Date: January 11, 2022
To: City Council
From: Ellen Hardgrove, City Planning Consultant
XC: Sandy Riffle, Deputy City Clerk
Bea Meeks, City Clerk
Allen Lane, CPH Engineering, City Engineering Consultant
Jim Winter, CPH Engineering, City Landscape Architect Consultant
Drew Smith, City Attorney
Re: Review of Mecatos Bakery and Café Site Plan/Waiver/Variance Application

This agenda item is related to the proposed site plan for the Mecatos Bakery and Café on the 0.917-acre parcel located at the northeast corner of Hansel and Hoffner Avenues, within the ECD. The proposal is an expansion of an existing 1,443 square feet building to 2412.5 square feet and a retrofit of the site to meet most of the ECD site design standards. Waivers are being requested where site standards are not met; a variance is also requested.

MECATOS REQUESTED WAIVER AND VARIANCE SUMMARY

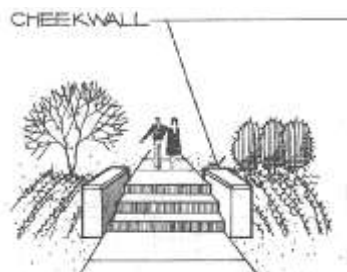
Approval of this request is a policy decision: whether this segment of Hoffner Avenue should reflect the ECD design given the ECD will not extend east of this parcel. On other side streets in the ECD, City landscape requirements of Chapter 114 are required. The proposed landscaping meets the Chapter 114 requirements when parking is adjacent to a road: minimum 7 feet wide buffer width, one shade tree for each 40 linear feet, or fraction thereof, and a continuous hedge at least 30 inches high at planting of a species capable of growing to at least 36 inches in height within 18 months, with the height of the hedge measured at grade of the adjacent parking lot.

To be noted, the proposed design is an improvement of the existing condition. The site plan shows an expansion of the existing five feet wide landscape buffer between the sidewalk and vehicular use area to 8.5 feet and the addition of a non-required parking island in the adjacent row of parking.

P&Z: Approval, conditioned on continuing the Hansel Avenue street wall around the corner along the Hoffner Avenue side in front of the two westernmost parking spaces, plus constructing columns at the top and bottom on both sides of the stairs that are proposed to connect the sidewalk along Hoffner into the property. The intent is to unify the look on both sides of the property.

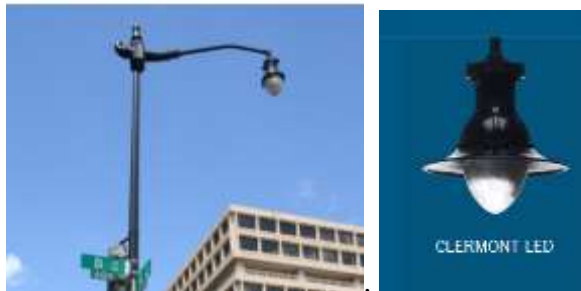
REQUEST: Waiver of Code Section 134-470(f)) to allow three, potentially non-decorative, light fixtures that are taller than 16 feet. A new 20 feet high light fixture is proposed along the north property line and two 28 feet tall existing light poles are proposed to be retained: one along Hoffner Avenue and one along the parking area east of the building. Illustration of the light fixtures has not been submitted to determine if decorative.

Staff: **Non-decorative light fixtures would be contrary to the envisioned ECD is not supported by staff. Additional information is needed related to height.**

Relative to the proposed light fixture on the north property line, unless there is objection from adjacent property owners, or other relevant information is presented at the public hearing to show that such lighting will be detrimental to the purpose and intent of the ECD, **staff has no objection to the height, conditioned on the fixture is decorative and coordinated with the fixture design along the Hansel Avenue side of the building.** The following provides decorative examples compared with that previously proposed by the applicant.

P&Z: **Approval of a waiver from Code Section 134-470(f) only for the existing light fixture along the Hoffner Avenue side of the property and the existing light fixture along the east side of the property; those existing light fixtures may remain. All other light fixtures shall conform with Code Section 134-470(f)**

SITE AND GEOMETRY PLAN

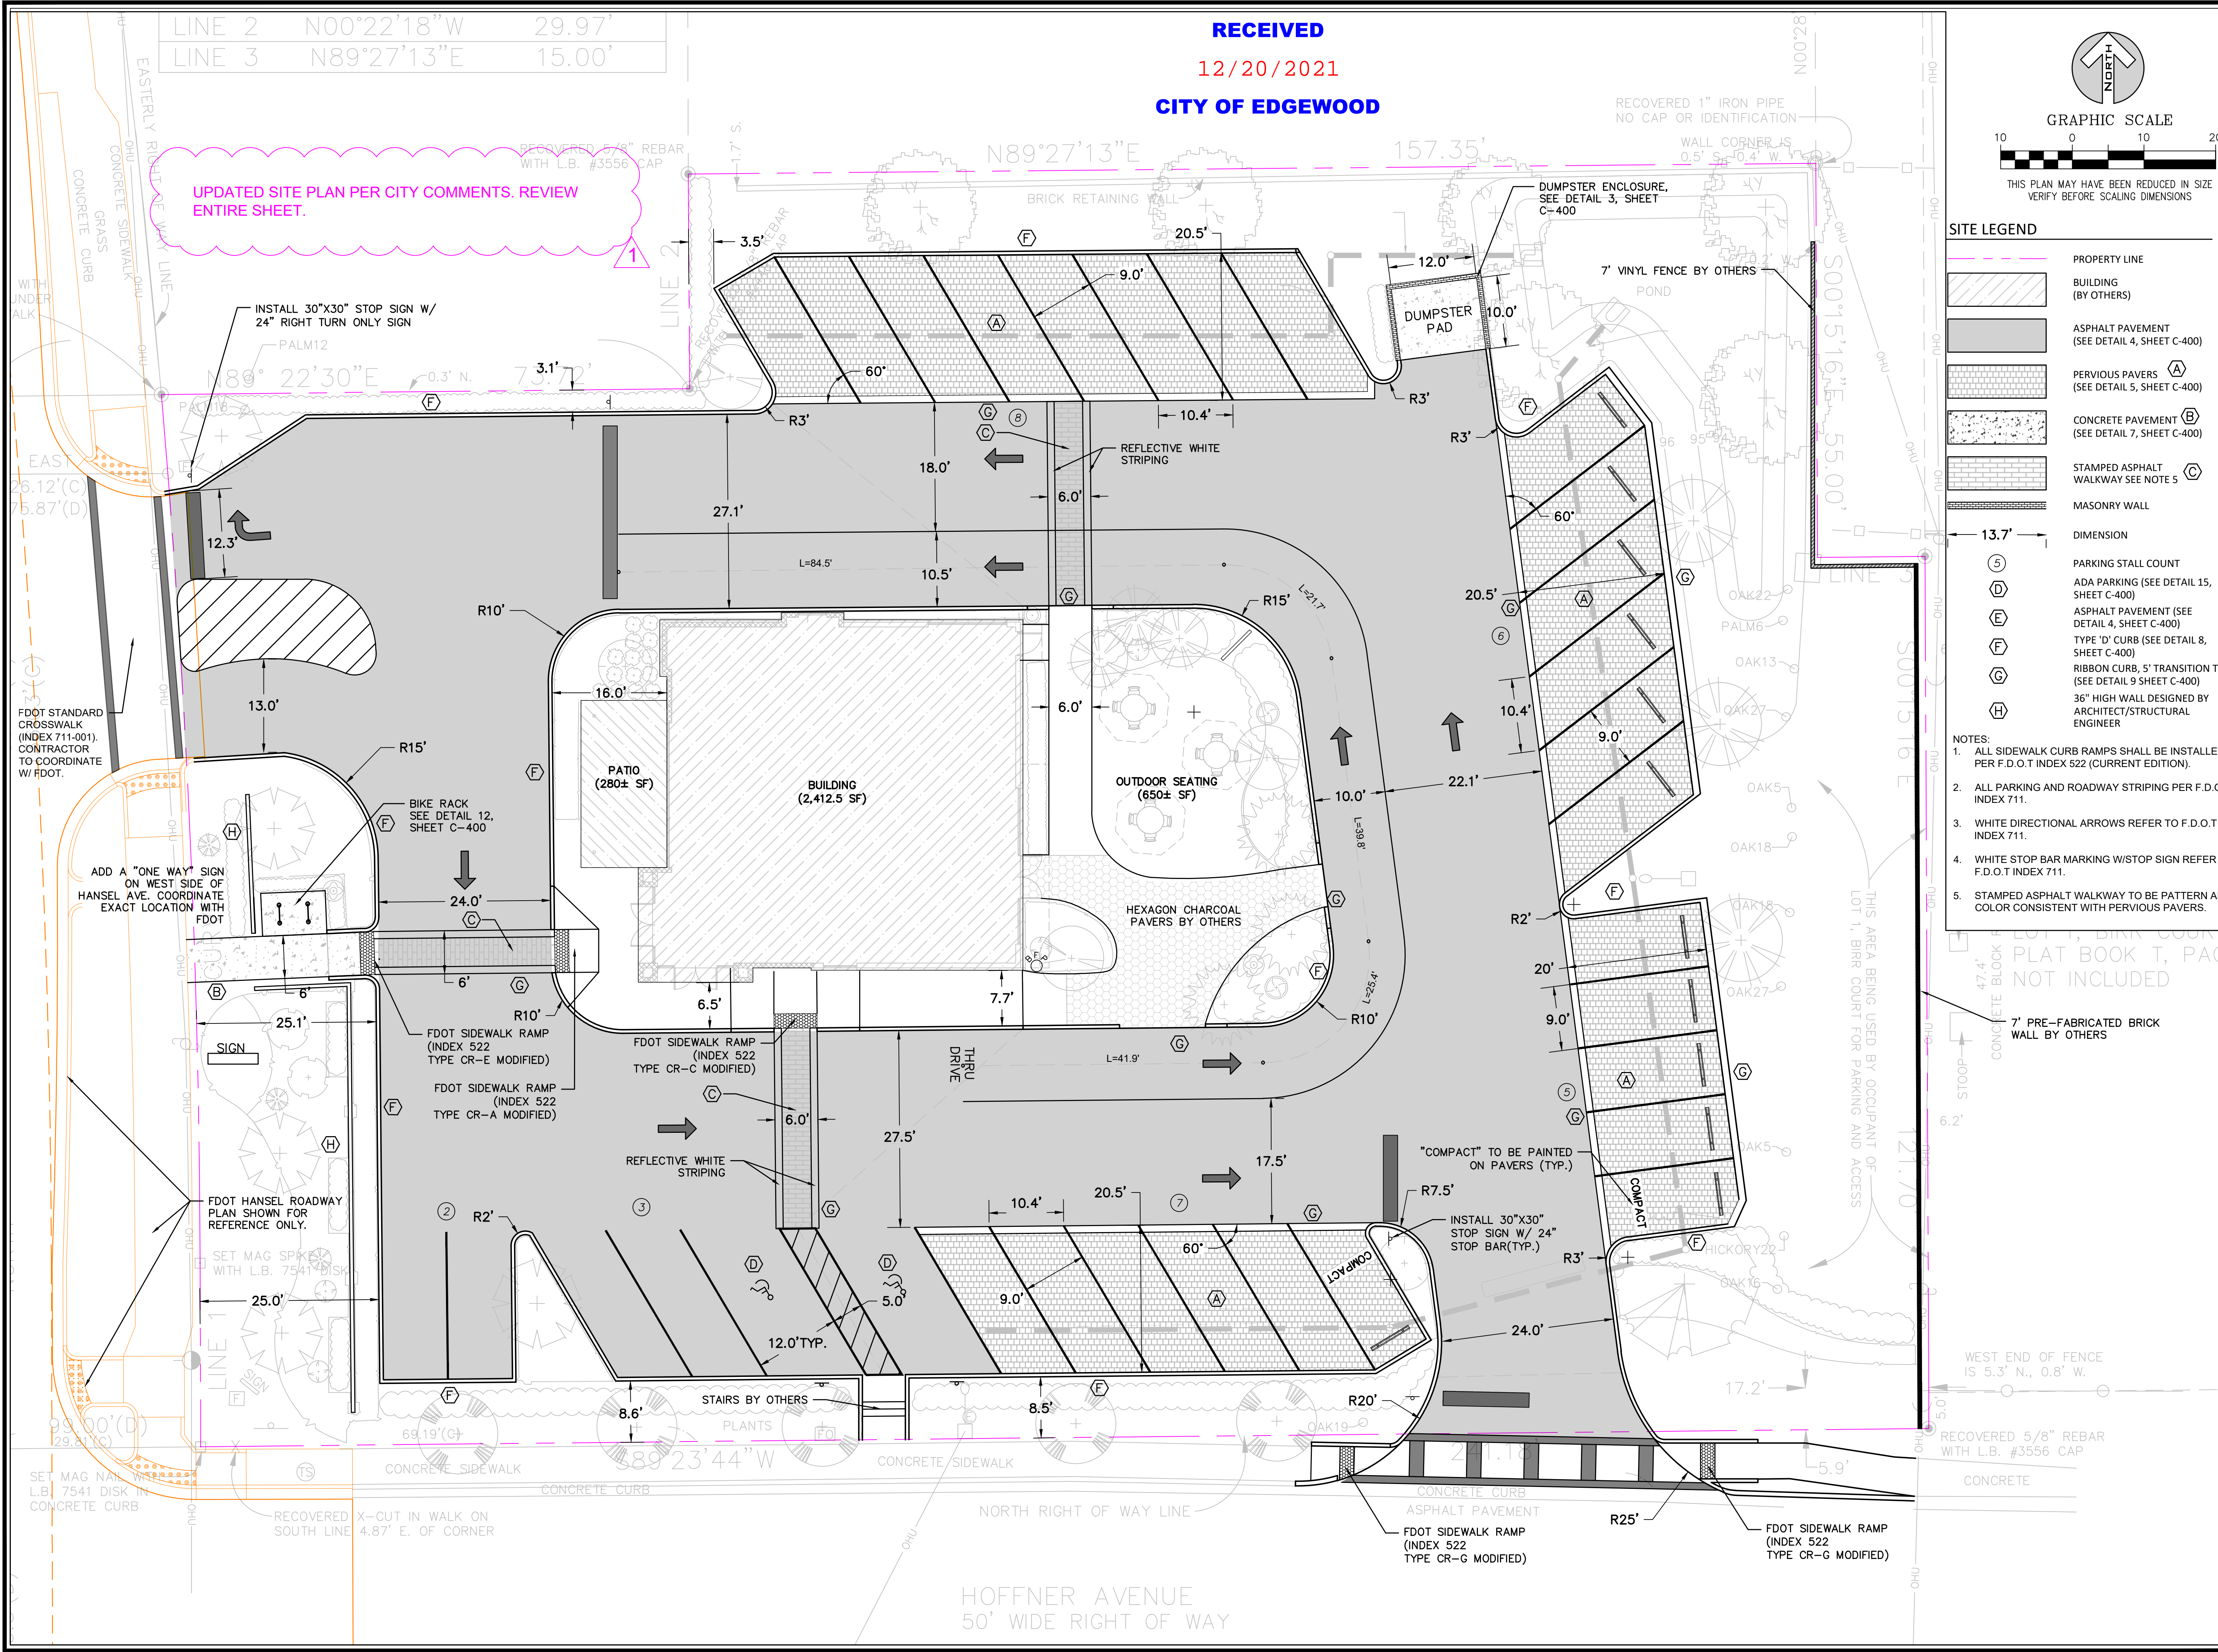
REQUEST: Waiver of Code Section 134-474(c)(4)(a) to allow parking in front of the imaginary line extended from the front building façade. As shown on the site plan, three parking spaces and a fraction of a fourth are in front of the imaginary line extended from the front façade of the building.

REQUEST: Waiver of Code Sections 134-471(2)e and 134-474(c)(4)a to allow the required street wall on the Hansel Avenue side of the property to be closer than 25 feet from the front property line, thus resulting in less than 25 feet wide of landscaped yard in front of the wall. As proposed, the southern ¾ of the wall is proposed to be located ±21 feet from the property line and the northern ¼ is proposed to be 8 feet from the front property line.

REQUEST: A waiver to Code Section 134-471(2)h, to allow less than fifteen (15) feet wide landscaped islands in parking lots. Such is proposed at the east end of the parking adjacent to Hoffner Avenue and at the west end of the parking along the northern property line.

REQUEST: Waiver of Code Section 134-470(c)(3), which limits height of fences anywhere in the district to a maximum of 48 inches. The applicant is proposing a 7 feet high fence along a portion of the east property line as shown below.

NOTE TO COUNCIL: If Council supports P&Z’s recommendation, staff recommends modification for clarity: Approve the Hansel Ave buffer width and street wall location as shown on the site plan presented at the hearing.

P&Z: Approval of a waiver of Code Section 134-470(c)(3) to allow a 7 feet high fence as shown on the site plan presented at the hearing conditioned on the fence being replaced with a wall consistent with ECD standards along the segment adjacent to the Low Density Residential future land use designated land if the “Brickwood Drive” property is acquired by the subject property’s owner.
